Project: MU/Patient Care Tower-1230- MRI Room

Subject: Addendum No. 1

ADDENDUM #1

TO CONTRACT DOCUMENTS FOR: Project #CP245321 – Patient Care Tower – T1230 MRI Room

BID PACKAGE	DATE	
1	07-09-2024	
ADDENDUM #1	08-16-2024	
NO.	DATE	
REVISIONS		
ELECTRICAL KEY PLAN		
DATE	PROJECT NO.	DRAWING NO.
07-09-2024	0012602	E0.2

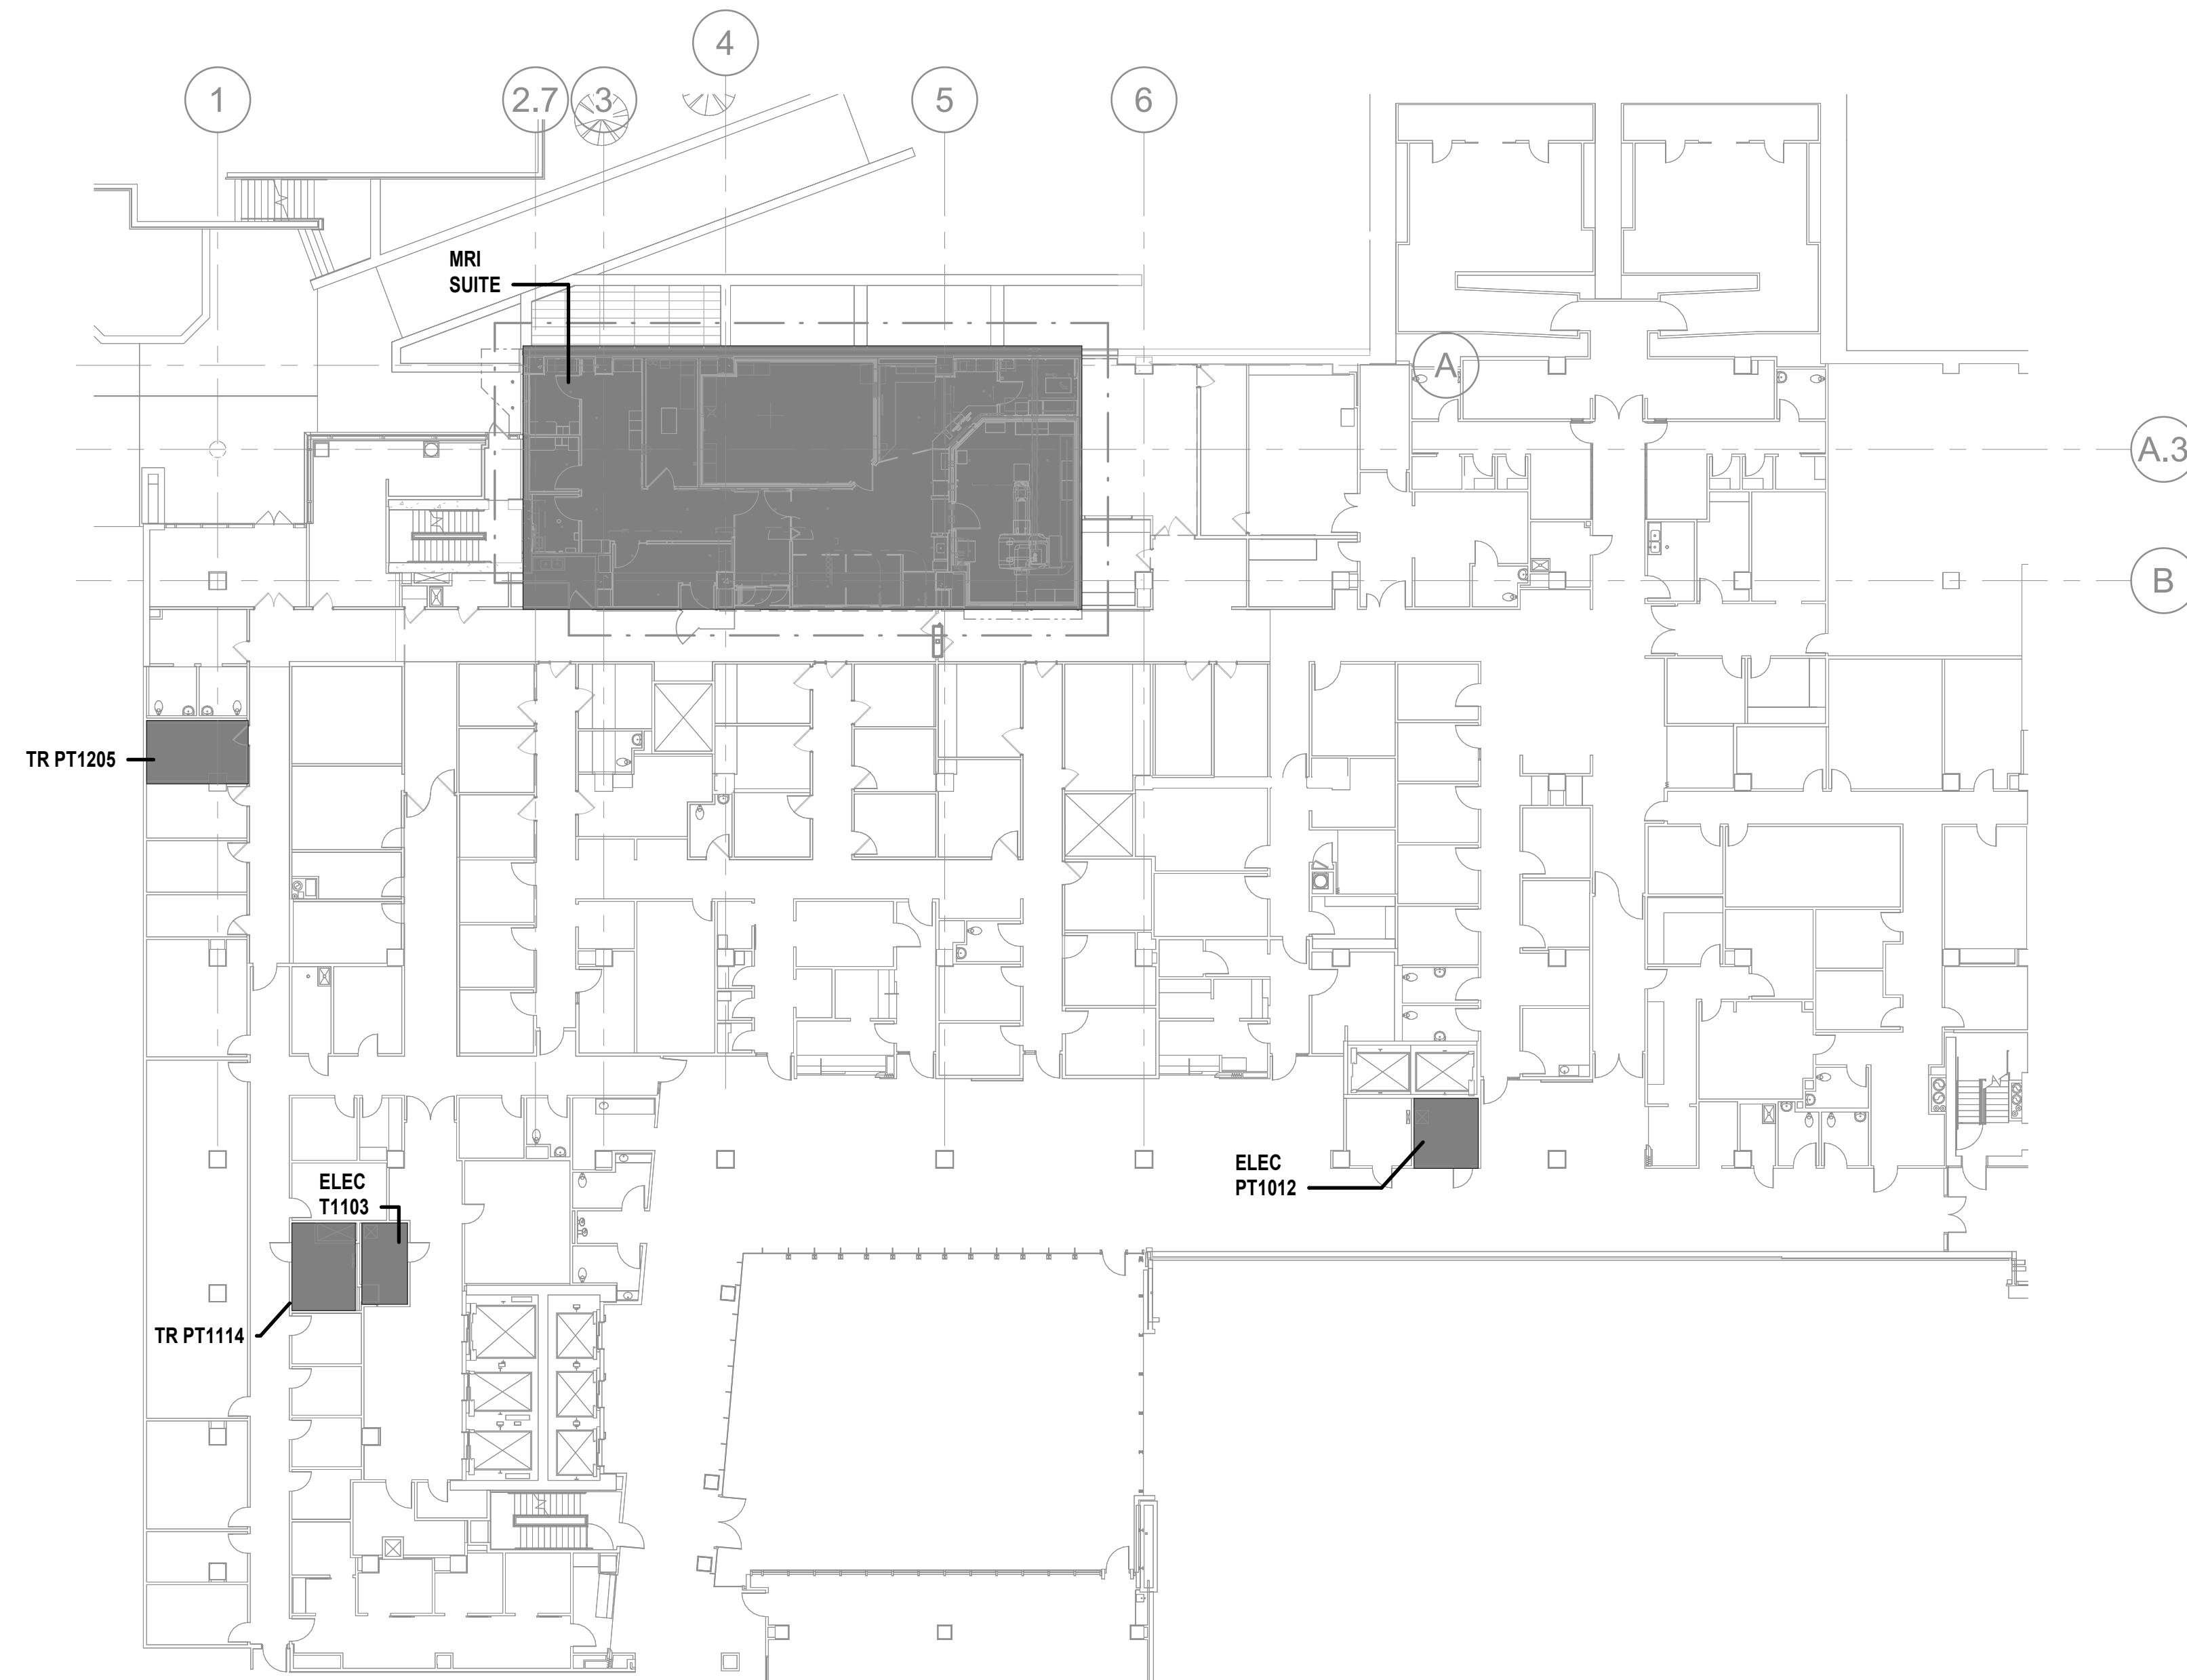
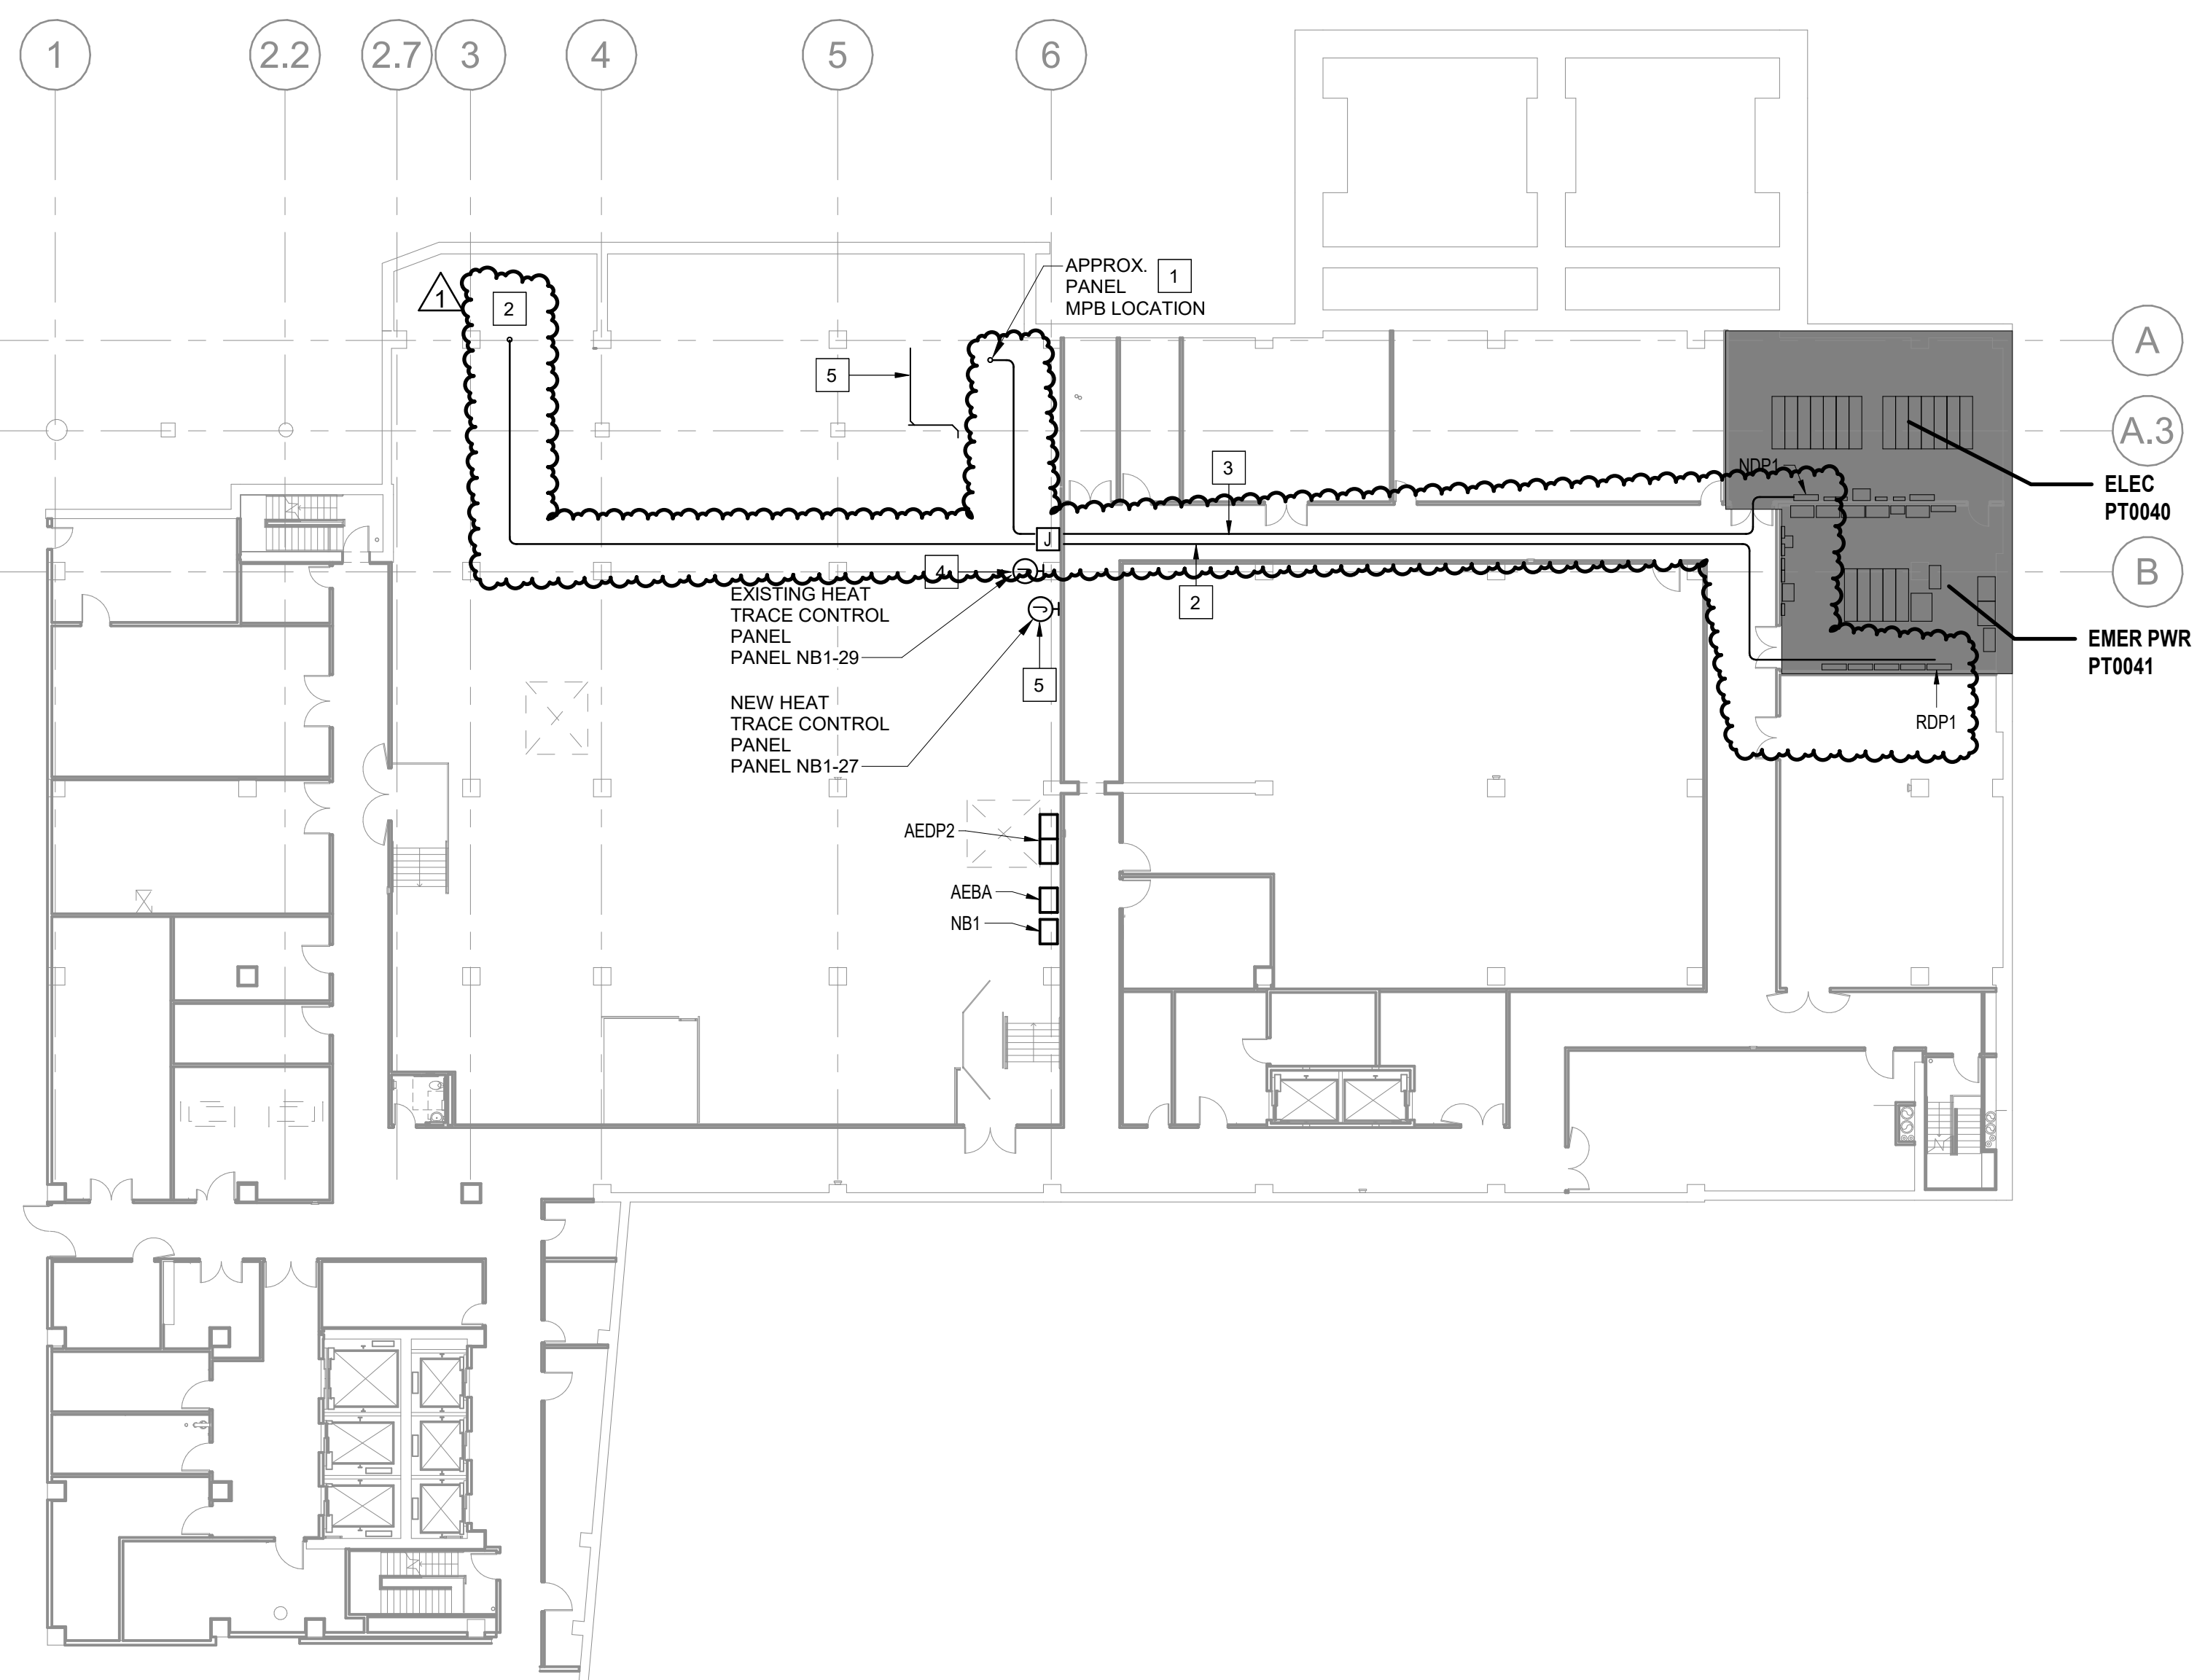
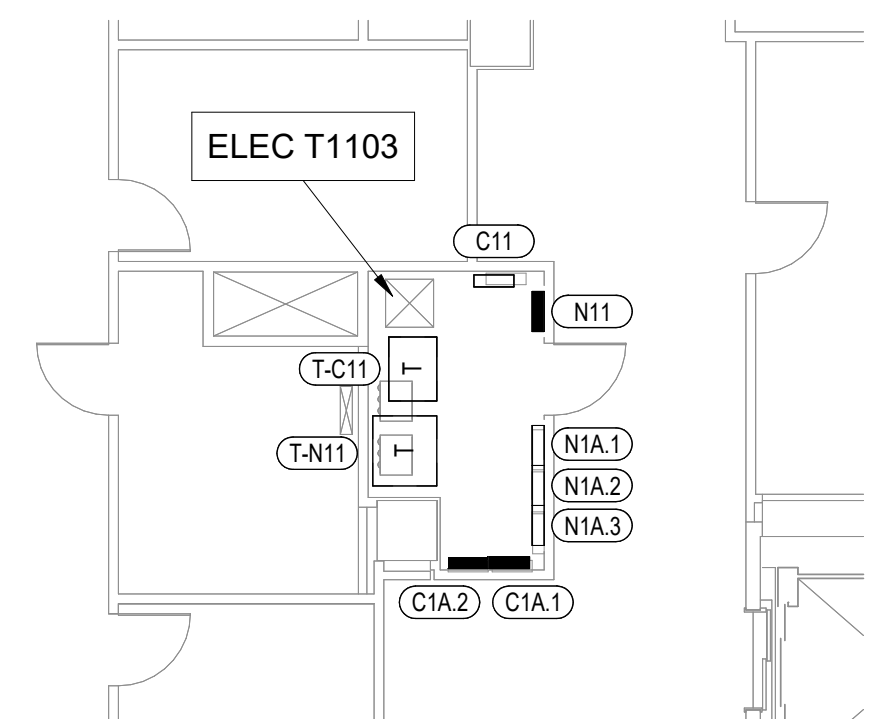
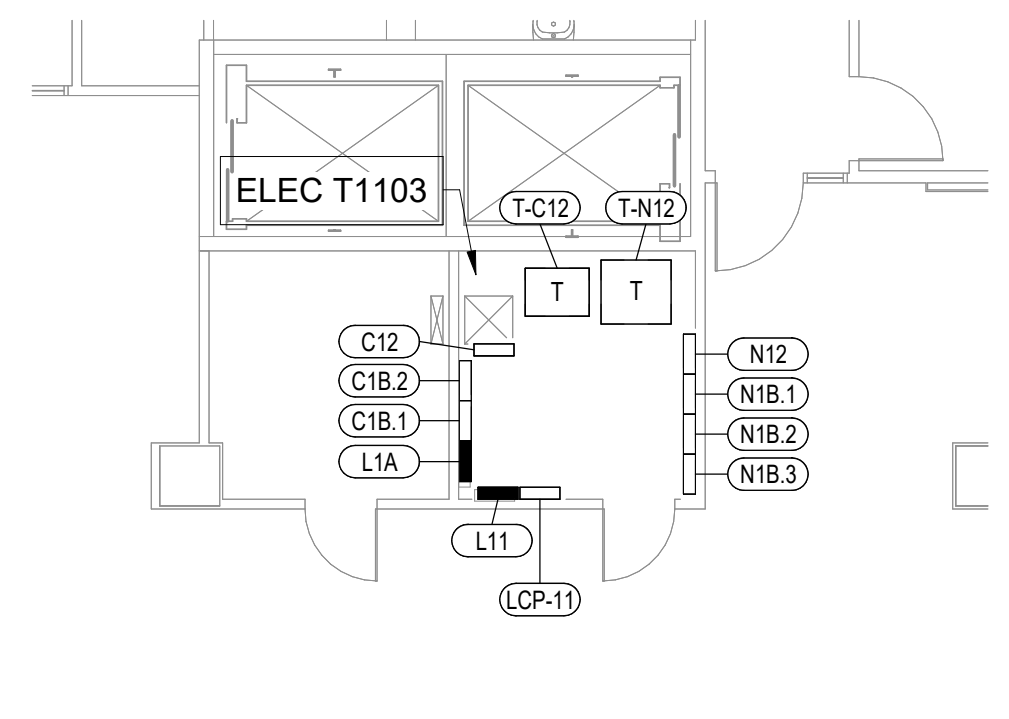
- 1) E0.1 – Electrical Legend
 - a. **REMOVED/CLEANED** unused legend items.
- 2) E0.2 – Electrical Key Plan
 - a. **ADDED** conduit routing on drawings for clarification purposes.
